Re: Tentative Waste Discharge Requirements for Santa Fe Aggregates, Inc. Kaweah River Rock Sand and Gravel Plant (NPDES No. CA0082201), circulated September 15, 2010 ("Draft Permit")

This letter conveys comments on behalf of Santa Fe Aggregates, Inc. on the Draft Permit for the Kaweah River Rock Sand and Gravel Plant (the "Facility"). We look forward to resolution of these issues through your review of the comments and discussion of any questions or further information needed on any of the subjects covered here.

KRRC pH

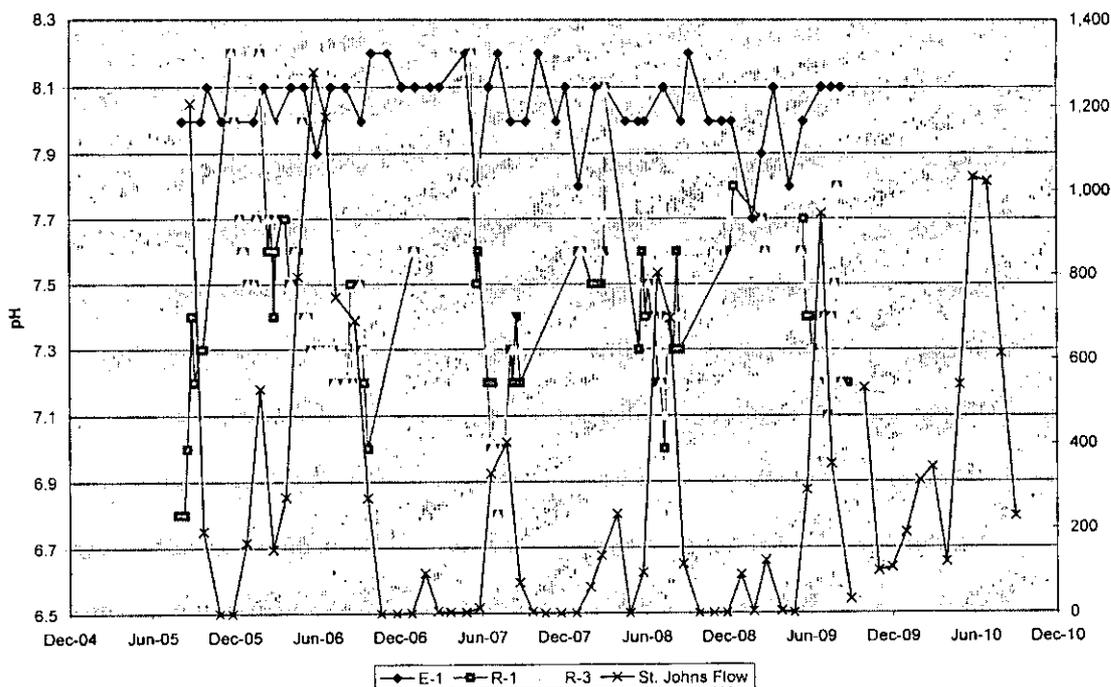
The condition specified in the permit is that the discharge not cause the pH of the water in the St. Johns River to fall below 6.5, exceed 8.3, or change at anytime more than 0.3 units from normal ambient pH. The chart entitled "KRRC pH", below, shows the pH data from R-1 and R-3, and the pH data from the effluent, E-1. In addition, the flow rate in the St. Johns River at McKay Point is shown on the chart.

The data presented on the KRRC pH chart show that the pH at both R-1 and R-3 has varied from 6.8 to 8.2, within the permit limits. The pH at E-1 has been more consistent, only varying from 7.7 to 8.2, with most of the measurements between 8.0 and 8.1. The data also clearly demonstrate that there is not a "normal ambient pH" in the river. The pH in the river can change dramatically based on short-term fluctuations in flow. For example, between May 14, 2007 and July 9, 2007, a period of seven weeks, the pH changed by 1.4 units, from 8.2 to 6.8, in both R-1 and R-3. This rapid change in pH was unrelated to the discharge at E-1 since the same magnitude of fluctuation was observed both upstream, at R-1, and downstream, at R-3.

During the period from August 2005 through April 2010, the pH in the upstream receiving water sample, R-1, was 0.4 units greater than the downstream sample, R-3, on five occasions out of approximately 250 weekly measurements. The difference in the pH between the upstream, R-1, and downstream, R-3, locations was never more than 0.4 pH units during this time period. The table below shows the dates where the pH differed between R-1 and R-3 by 0.4 pH units. The table also shows the difference between the flow in the river at those times and the discharge flow rate. The very small volume of the discharge at E-1 is insufficient to cause a measurable change in pH in the receiving water. For example, in February 2006, the flow in the St. Johns River was 152 cfs whereas the discharge was 0.88 cfs, or one-half of one percent of the river flow. The data from May 2007 is even more definitive in that the E-1 discharge pH of 7.8 could not have changed the pH in the river from 7.6 to 8.0.

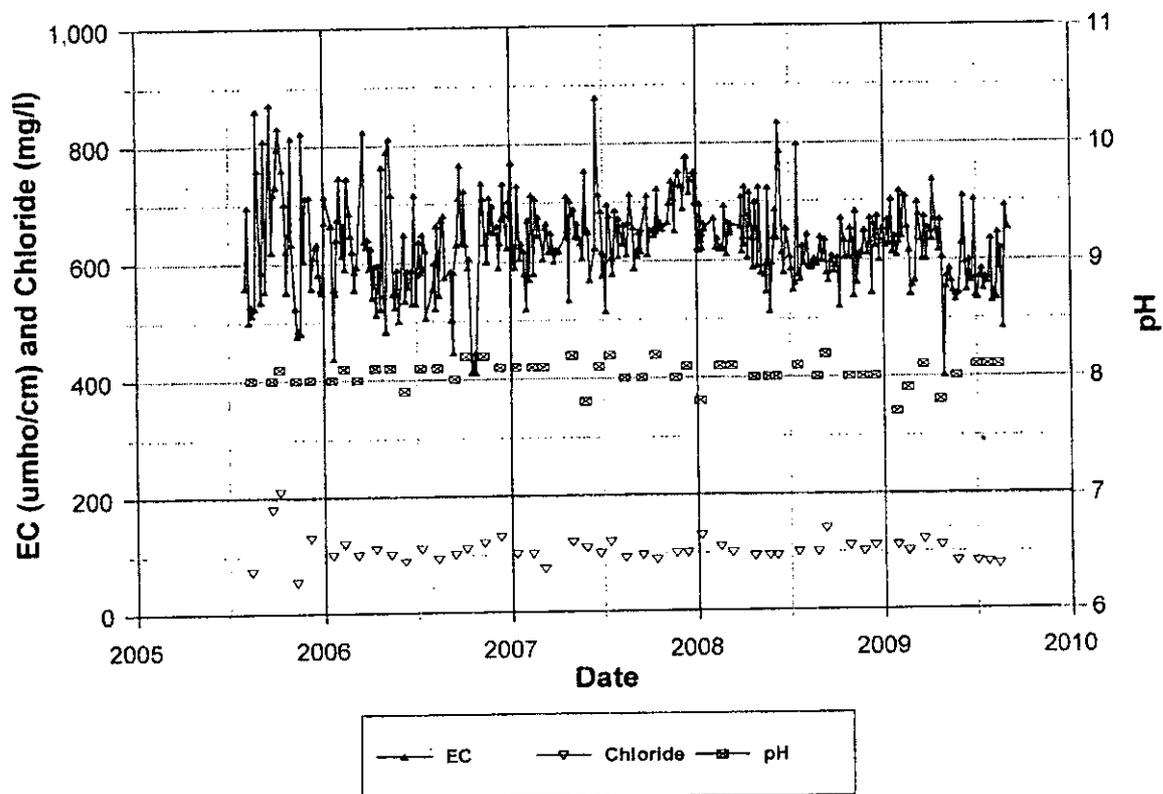
Monitoring of electrical conductivity (EC) has been conducted on a biweekly basis. The minimum and maximum values are 402 and 879 umho/cm, respectively; the average value is 630 umho/cm. In general, EC shows a seasonal variation with the highest values typically during the late fall to early winter period, as shown by the graph of effluent EC, chloride, and pH values below (Figure 4 in the Luhdorff & Scalmanini Technical Report dated November 30, 2009, submitted with the Report of Waste Discharge ("November 2009 Technical Report")). With a long-term maximum daily value of 879 umho/cm, the permit-specified maximum daily limit for EC of 1,000 umho/cm has never been exceeded.

Monitoring of chloride has been conducted monthly and the long-term minimum and maximum values are 53 and 210 mg/l, respectively; the average concentration is 105 mg/l. In general, chloride shows a seasonal variation similar to EC, with the highest concentrations typically during the late fall to early winter period, as shown in the figure above.

E E-1
 O OFFICE-WELL
 J JOBE

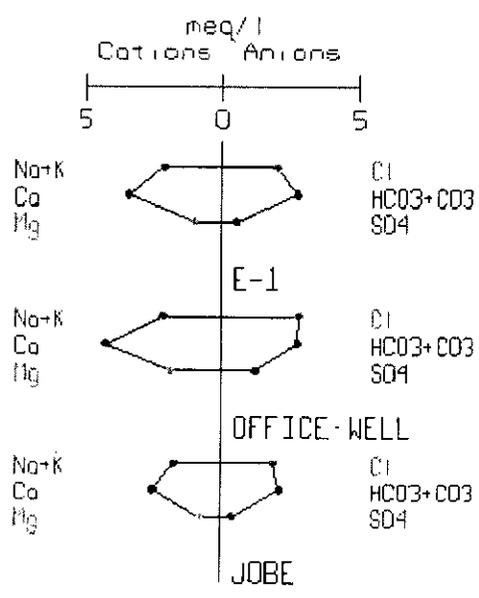
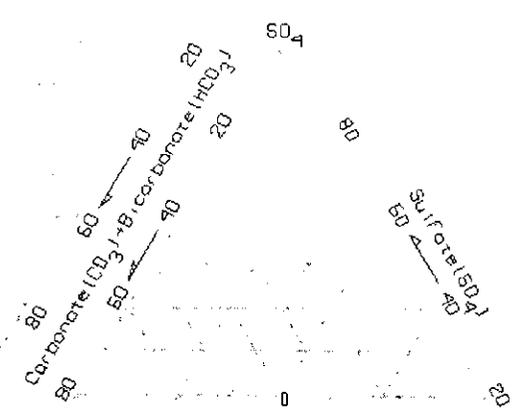
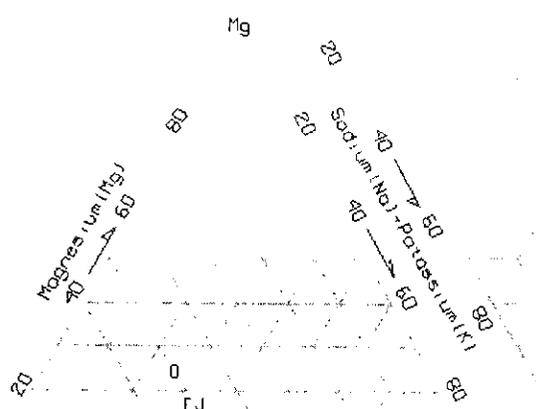
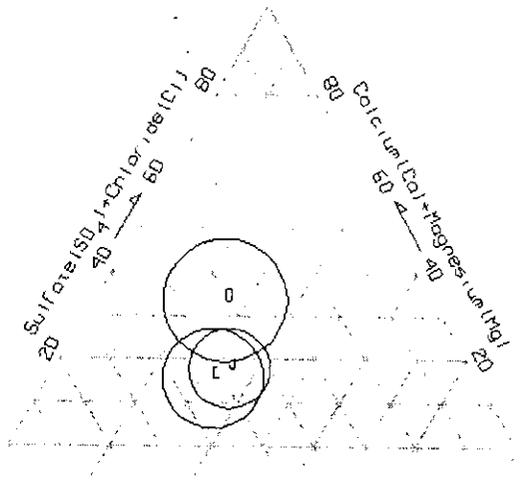
In December 2010, the Facility collected groundwater quality data from an upgradient well next to the Facility office (the “Office Well”), from the E-1 discharge (which is primarily groundwater), and from a downgradient well within the recharge area (the “Jobe” well). These samples were analyzed for general mineral parameters and metals to allow evaluation of standard water-quality and water-type studies (for example, per USGS Water-Supply Paper 2254, *Study and Interpretation of the Chemical Characteristics of Natural Water*). The data have been plotted on standard Stiff Plots and a Piper Diagram, as shown below. The data shows that the groundwater at all three locations (the E-1 discharge at the time of sample collection consisted almost entirely of groundwater being dewatered from the pit) is of the same type – a calcium-bicarbonate water. Most notable was that for all major ions and metals, concentrations were slightly higher in the upgradient Office Well and were lower at the downgradient locations.

The data clearly demonstrate that, after more than a half-century of operation, there is no evidence that the Facility has had any influence on downgradient groundwater quality.

Santa Fe understands that the Regional Board must consider the potential of a facility's discharges of waste to degrade groundwater. However, at this Facility there is ample site-specific data demonstrating that there is no potential for degradation. Therefore, the Draft Permit should be revised to delete Provision VI.2.d and the quarterly groundwater monitoring requirements.
